Product Change Notification / ALAN-08K00J271

CCB 4767 Final Notice: Qualification of ANAP as an additional assembly site for selected Atmel AT91SAM7S1xx and AT91SAM7S2xx device families in 64L LQFP (10x10x1.4mm) package.

CCB 4767
Pre and Post Change Summary
PCN# ALAN-08KOOJ271

Pre and Post Change Summary

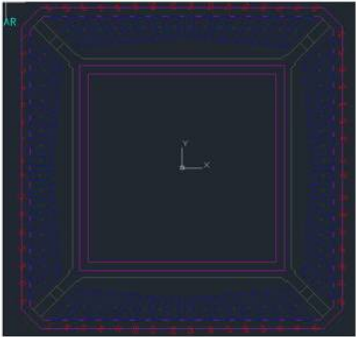
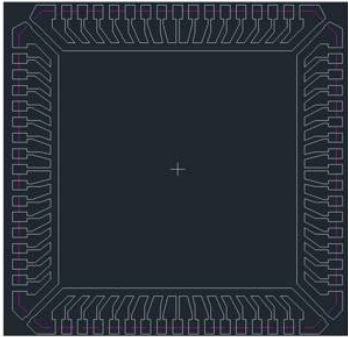
Assembly location		ASE Inc. (ASEK)	Assembly location		Amkor Technology Philippine (P1/P2), INC. (ANAP)
Die attach material		CRM-1076WA	Die attach material		3230
Mold compound material		G631HQ	Mold compound material		G631HQ
Lead frame material	Material	C7025	Lead frame material	Material	C194
	Process	Stamped		Process	Etched
